Technical Bulletin
No: 120 – Power Supply Conversion
from 120V AC to 120/240V AC

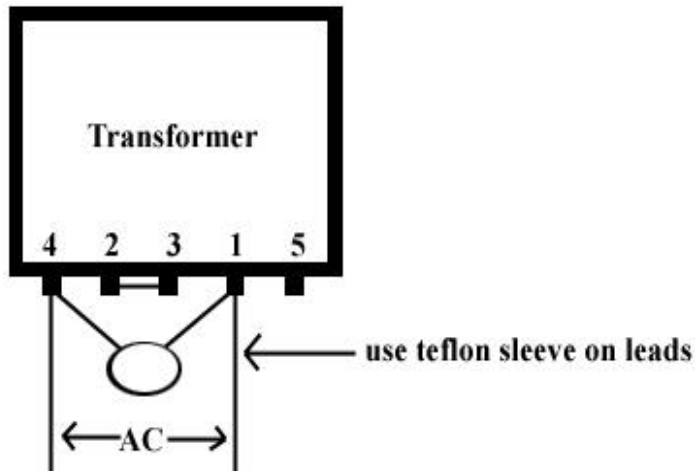
Power Supply Conversion:

For 230/240 AC 50/60 Hz:

* Replace MOV
with P/N 8042
V250La20A

- If connecting a heavy duty (18 channel) supply, be sure to modify both supplies.
- Change fuses to 1 A SB 1/2 SB
(PS-1) (PS-2)
- Plug unit into AC outlet, check for =12V DC at collector of regulator priss transistors.
- Cut off AC plug and tin leads
- Tag Cord "230/240 VAC 50/60 Hz
